Access Compliance Report

Public Rights-of-Way

Intersection ID: 30339	Main Street: DULIN_CREEK_BV	Cross Street: REEDY_PLANTATION_RD	Location: NE
ADA ID: EC229406E7AB	Ramp Type: PerpDiag	Initial Pass/Fail: Pass	Overall Compliance: No
Severity Score: 0			
Codes/Mitigation Info/Possible Solution		Field Measurements/Component Compliance

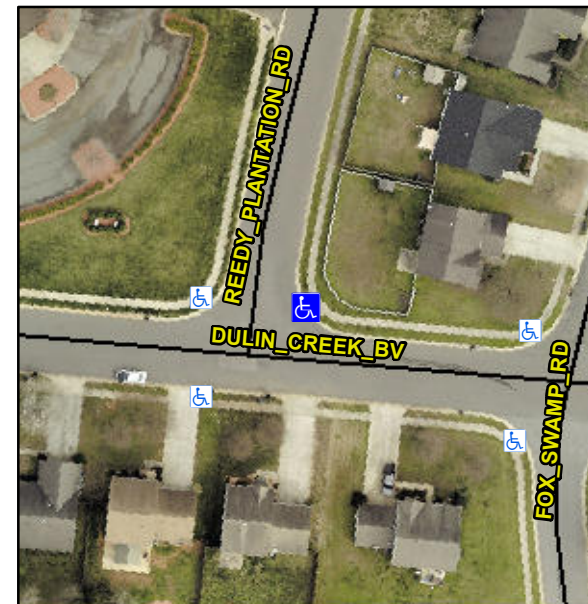
Not Found, R304.2.1, R304.2.2-Perp, R304.3.2-Para, R305.2

Compliance	Description	Data	Compliance	Description	Data
N/A	Ramp Length (in)	47.5	Yes	Ramp Slope (%)	6.5
Yes	Ramp Width (in)	48.0	Yes	Ramp XSlope (%)	1.1
N/A	Flare Type LT	Sloped	N/A	Flare Type RT	N/A
N/A	Flare Slope LT (%)	0.1	Yes	Flare Slope RT (%)	3.4
N/A	Flare Traversable LT?	Yes	N/A	Flare Traversable RT?	Yes
No	Landing Length (in)	47.0	Yes	DWS Provided?	Yes
Yes	Landing Width (in)	48.0	Yes	DWS Contrast?	Yes
No	Landing Slope (%)	5.2	Yes	DWS Length (in)	24.0
Yes	Landing X Slope (%)	0.8	Yes	DWS Full Width?	Yes
N/A	Landing Curb? (Y/N)	No	No	DWS Offset (in)	2.5
N/A	Shared Landing?	No			
Yes	Gutter Ponding?	No	Yes	Gutter Slope (%)	0.7
Yes	Gutter Lip Ht (in)	0.0	Yes	Gutter X Slope (%)	1.7
N/A	Painted X Walk1?	No	N/A	Painted X Walk2?	No
	X Walk 1 Direction	To S		X Walk 2 Direction	To W
N/A	X Walk 1 Width (in)	N/A	N/A	X Walk 2 Width (in)	N/A
	X Walk 1 Slope (%)	1.1		X Walk 2 Slope (%)	0.3
	X Walk 1 X Slope (%)	2.0		X Walk 2 X Slope (%)	0.5

N/A	Ramp inside XWalk1?	N/A	N/A	Ramp inside XWalk2?	N/A
	Road Slope (%)	1.5	N/A	Clear Space?	Yes
	Road X Slope (%)	0.9	N/A	Clear Space to XWalk (in)	N/A
Yes	Any Obstructions?	No	Yes	Storm Grate/Utility Hazard?	No
	Obstruction Type			Storm Grate/Utility Type	
		N/A			N/A
			Yes	Surface Condition? (G/P)	Good

Remove & Replace Curb Ramp With Two New Directional Ramps or Equivalent.
